Appl. No. 10/040,023 Atty. Doc. No. 042390.P3849 Reply to Office action 5/23/03

REMARKS

FIG. 1 (PRIOR ART)

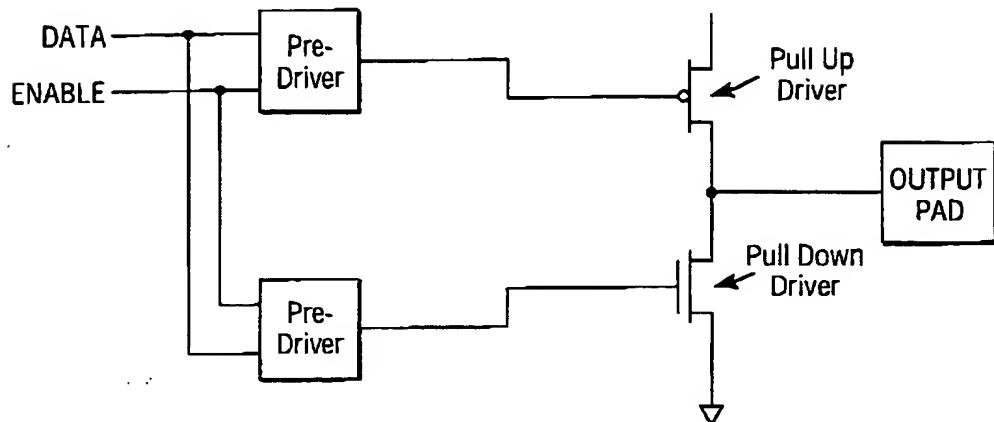
Reconsideration of this application, as amended, is respectfully requested. The office action objected to the drawings because figure 1 should be labeled as prior art, figure 4 contains two I_{cap} annotations and these two do not represent the same thing, figure 4 is not a transistor representation of figure 3, and the drawings do not show a predriver coupled between the capacitor and the first driver amplifier. The Examiner has acknowledged that claims 1-19, and 24-26 are directed to allowable subject matter.

In the specification, the paragraphs have been amended to correct minor editorial problems as well as references to I_{cap1} and I_{cap2} of Figure 4. In amended Figure 1, the label "Prior Art" has been added. Figure 4, as amended, changes the " I_{cap} " annotation to I_{cap1} and I_{cap2} . In the claims, claim 12 has been amended to state "a pre-driver amplifier coupled to the capacitor and the first driver amplifier."

FIG. 6

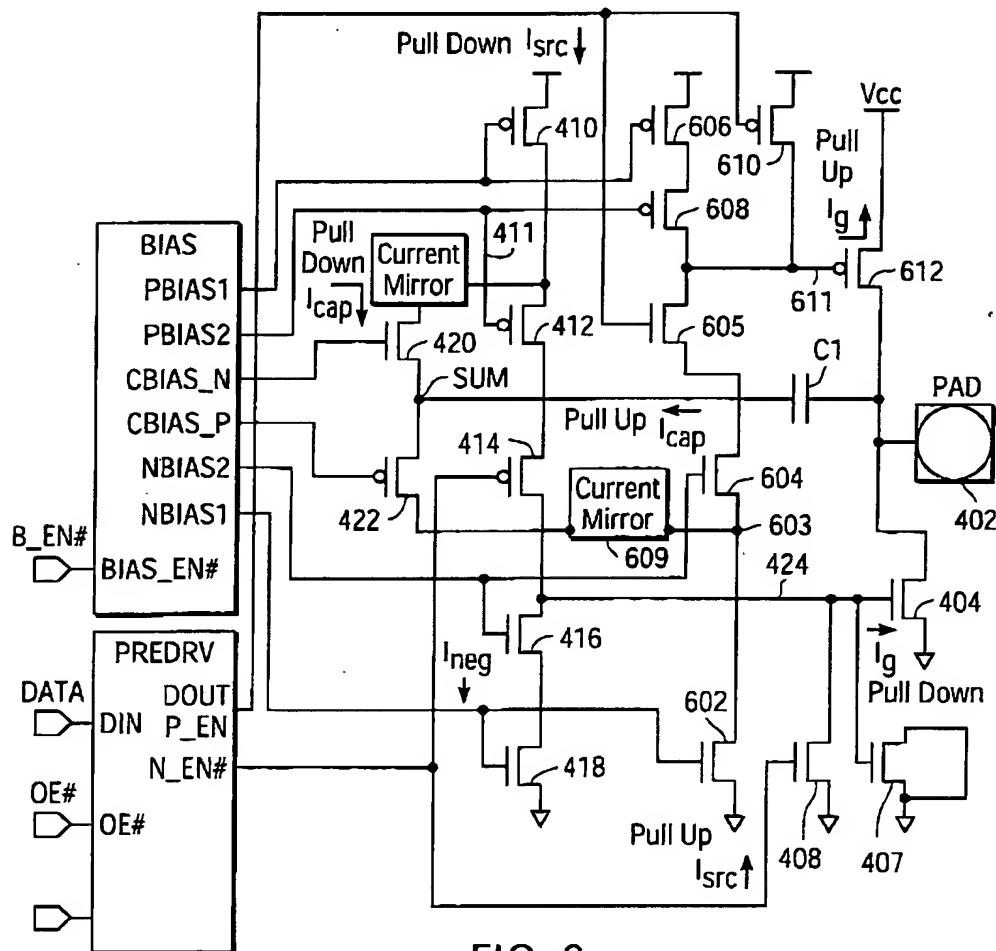
In contrast to the Office Action's assertions, Figure 4 may be an equivalent transistor level circuit of Figure 3. However, the amended description of Figure 4 makes any argument moot. In contrast to the Office Action's assertions, the figures, such as Figure 6, do illustrate multiple predriver amplifiers, driver amplifiers, and current mirrors. However, amended claim 12 makes any argument moot.
